REMARKS

AMENDMENTS TO THE DRAWINGS

The attached sheet(s) of drawings includes changes to Figure 1—3.

*Fig. 1*

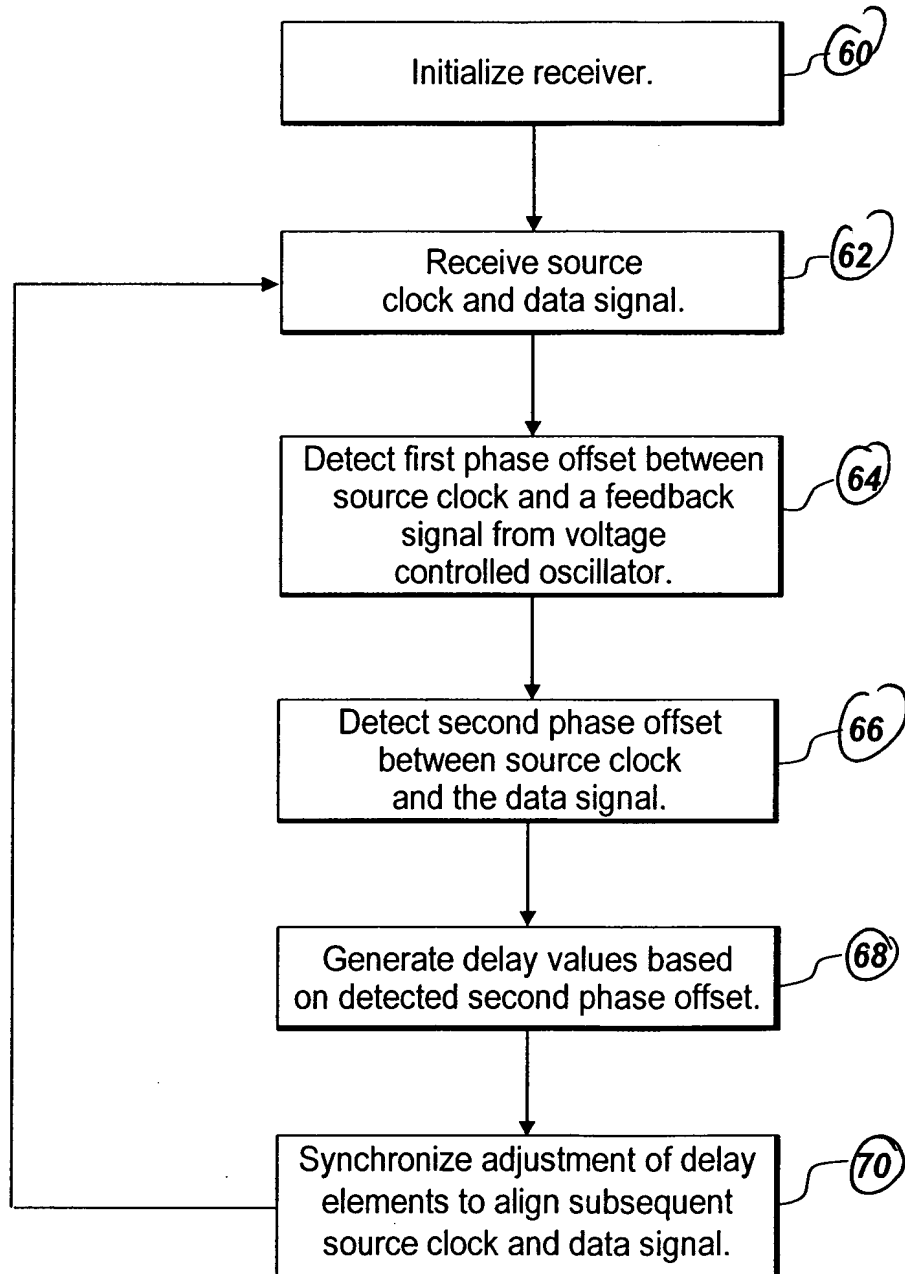
The Examiner objects to the Drawings because of non-legible reference numbers. Applicants subsequently amend the Drawings to include formal reference numbers.

The Examiner further objects to the Drawings because the Examiner suggests that the Drawings do not show every feature of the invention specified in the claim. Specifically, the Examiner request that the first receiver stage and the second receiver stage of the first and second receivers must be shown or the features canceled from the claims. Applicants hereby amend the drawings to include a first and second receiver as limited by claim 3. Applicants respectfully submit that claim 3 does not include the limitation of a first state and a second stage as stated by the Examiner. Applicants respectfully submit that the amended Drawings together with amended claim 3 show features of a first receiver stage and the second receiver stage of the first and second receivers, which is mentioned in several places in the Specification. No new matter is added.

The Examiner further requested that the integration amplifier of the second stage of the first receiver as well as the integration amplifier of the second stage of the second receiver must be shown as claimed in claim 6 or the features canceled from the claim. Applicants hereby amend claim 6 to recite the synchronous interconnect structure comprising an integration amplifier. Applicants respectfully submit that amended claim 6 now correspond to the drawings. No new matter is added.

The Examiner further request that the delayed locked loop circuit must be shown as claimed in claim 14 or the features canceled from the claim. Applicants hereby amend the Drawings to include the feature of a delayed locked loop circuit, which is mentioned in the Specification in several places. Applicants also amend claim 14 to clarify the invention. No new matter is added.
